**SAN ANTONIO WATER SYSTEM
FM 78 -12" Water Main
Woodlake to Congressional
SAWS JOB NUMBER: 10-4002
SOLICITATION NUMBER: B-11-054-RA
ADDENDUM NO. 1**

October 26, 2011

The purpose of this addendum is to issue a revision of the plans and contract documents for FM 78 – 12" Water Main Woodlake to Congressional, SAWS Job Number: 10-4002.

DEVELOPER: SAN ANTONIO WATER SYSTEM	
CONT. BUDGET PROJ. *	
SUBMITTED	
APPROVED	
MAP No. 206-600, 208-600, 208-602	SHEET 12 OF 32
DR. DH&MM CK. ETM	JOB No. 10-4002

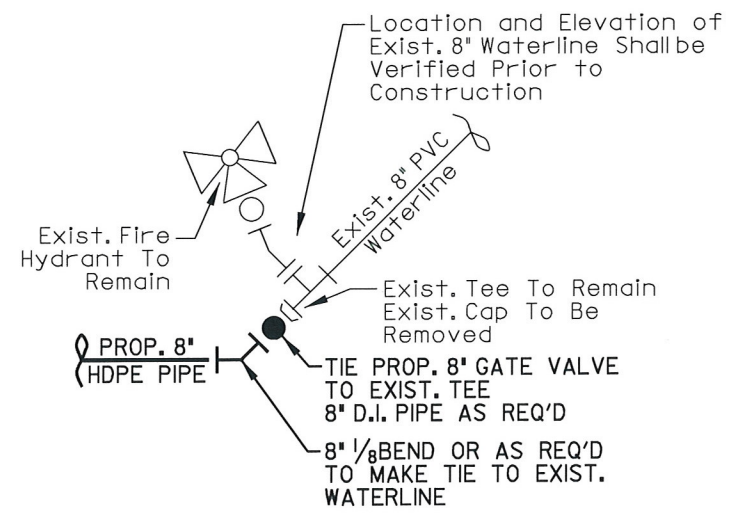
Question 1. Is fire hydrant on Legend Point to be removed? No. New water main will be tied to existing water main in Legend Point without removing fire hydrant. Revised plan sheet is attached.

- Plans
 - Sheet 12 of 32: Sheet has been revised to remove note stating "Remove & Replace Exist. Fire Hydrant w/6" Valve". Revised sheet is attached.

No.	Revision	Drawn	Approved	Date
1	Remove FH Note	KRG	ETM	10-24-11

CONTRACTOR SHALL NOT INSTALL 8" WATER MAIN SHOWN ON THIS SHEET UNTIL AUTHORIZED BY SAWS. IF WATER MAIN IS NOT INSTALLED, 8" GATE VALVE ON F.M. 78 SHALL BE PROVIDED WITH SOLID CAP. (NO SEPARATE PAY ITEM)
